FIRE SAFETY INSPECTION REPORT

VISION APPARELS (PVT) LTD

ACCORD
on Fire and Building Safety in Bangladesh

May 4, 2014

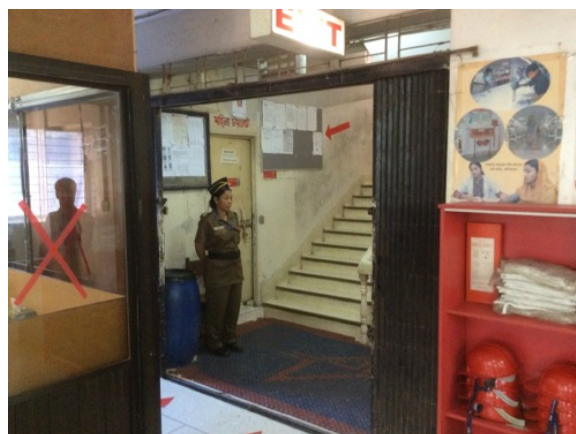
No.	Category	Finding	Recommendation	Remediation Timeframe
F-1	Fire Rated Construction	The exit stairs are not separated from work areas, other spaces on each floor by fire-rated construction.	Provide minimum 1.5-hr fire rated doors and seal all unprotected openings to separate the exit stairs from work areas and other building spaces on all floor levels. Ensure that the fire doors are self-closing and positive latching and that they are provided with fire exit (panic) hardware where serving production floors. If fire doors are required to be held open for functional reasons, provide automatic-closing devices tied to the fire alarm system.	Within 3 months

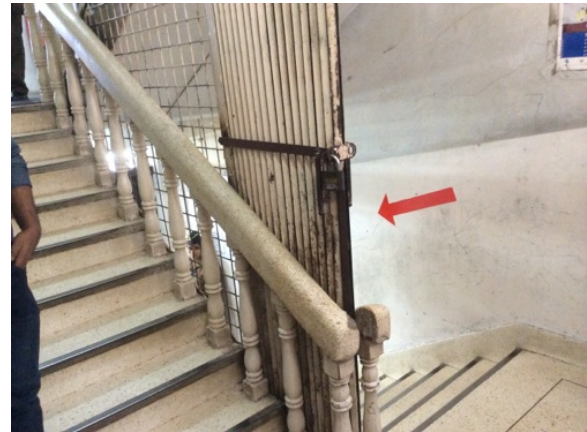
F-7	Egress	Collapsible gates and sliding doors are provided at building exits, exit stairs, along egress routes and exit discharge.	Replace all gates and sliding doors along the means of egress with side-hinged, swinging egress doors. If locks are required for security reasons, utilize special door locking features complying with NFPA 101.	Within 1 month
-----	--------	--	--	----------------

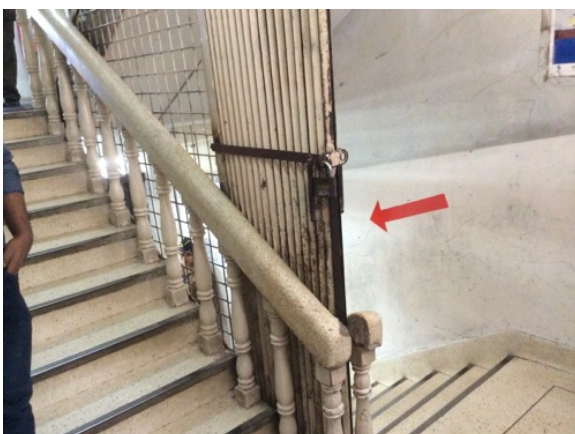
F-8	Egress	Exit capacity is not adequate for the 8th floor occupant load.	Reduce occupant load to not more than available exit capacity or provide additional exits.	Within 3 months
F-9	Egress	Handrails are not provided in southwest stairwell.	Provide handrails on at least one side of exit stair.	Within 3 months

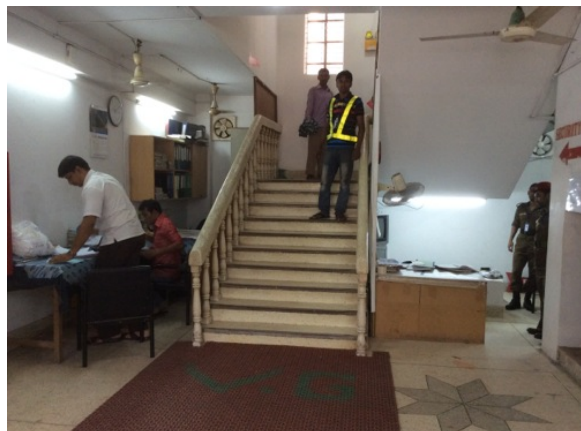
F-11	Fire Protection	The high-rise building has an occupied floor greater than 23m (75 ft) and is not provided with automatic sprinkler protection. The large occupant loads, heavy fuel loading, and anticipated extended egress times warrant sprinkler protection.	Provide automatic sprinkler protection throughout the building in accordance with NFPA 13.	Design within 6 months, install within 12 months
F-12	Fire Protection	Inspection, testing, and maintenance for the fire alarm system was not in accordance with NFPA 72.	Inspect, test and maintain the fire alarm system, and keep written records on-site, in accordance with NFPA 72.	Within 3 months

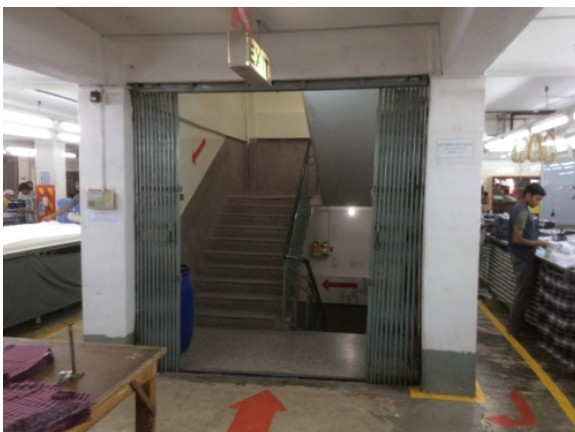
No.	Category	Finding	Recommendation	Remediation Timeframe
F-1	Fire Rated Construction	The exit stair are not separated from work areas, other spaces on each floor by fire-rated construction.	Provide minimum 1.5-hr fire rated doors and seal all unprotected openings to separate the exit stairs from work areas and other building spaces on all floor levels. Ensure that the fire doors are self-closing and positive latching and that they are provided with fire exit (panic) hardware where serving production floors. If fire doors are required to be held open for functional reasons, provide automatic-closing devices tied to the fire alarm system.	Within 3 months
